**MONTGOMERY COUNTY PLANNING DEPARTMENT**  
THE MARYLAND-NATIONAL CAPITAL PARK AND PLANNING COMMISSION

**Staff Report: Limited Site Plan Amendment 82003025B, Lofts 24 – Silver Spring Park**

**APPLICATION DESCRIPTION:** CBD-1/Fenton Village Overlay Zone; 0.38 acres; Limited Amendment to reflect as-built conditions on the site and lighting plans, and minor revisions to the landscape plan; located in the SW quadrant of the intersection of Fenton Street and Bonifant Street, Silver Spring CBD Sector Plan.

The streetscape on Georgia Avenue and Colesville Avenue in front of the Lee Building incorporates granite pavers.

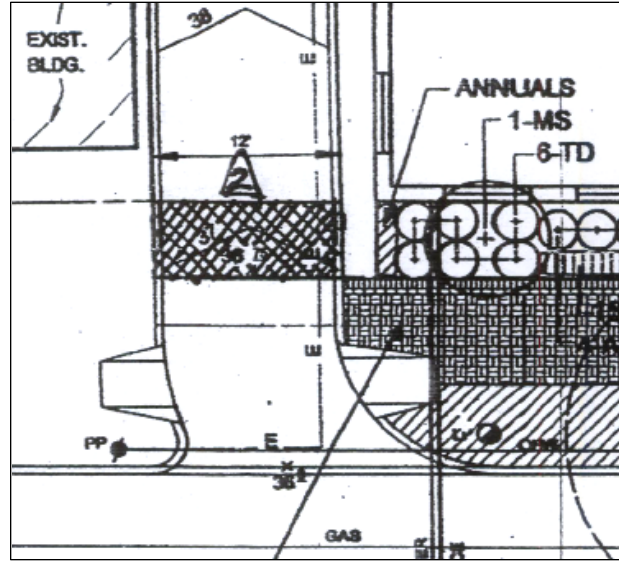
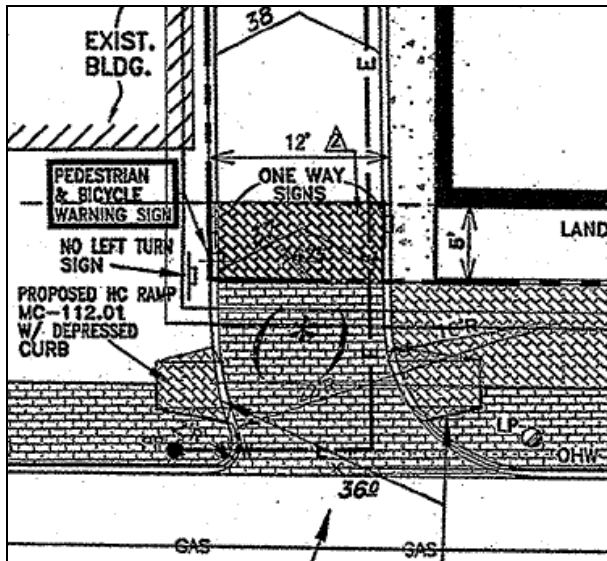
The third issue relates to concerns of using granite pavers as a non-standard material for entryways and the public use space and potentially being slippery under certain weather conditions. Staff argues that granite can have many different finishes ranging from more to less

polished and it is the responsibility of the Applicant to provide a finish that is appropriate. As street pavers, granite is usually very porous, which makes it non-slippery. On streetscape applications, granite is widely used for accent and to highlight specific features. As an example, the streetscape on Georgia Avenue and Colesville Avenue in front of the Lee Building in downtown Silver Spring incorporates granite pavers.

- a. Provide black granite pavers with a 2-inch thickness, mortared in place at the three entryways to the building and public use space at the corner of Bonifant and Fenton Streets. The individual pavers must be 2" x 24" x 24" with a 2" x 12" x 12" matching border as originally approved.
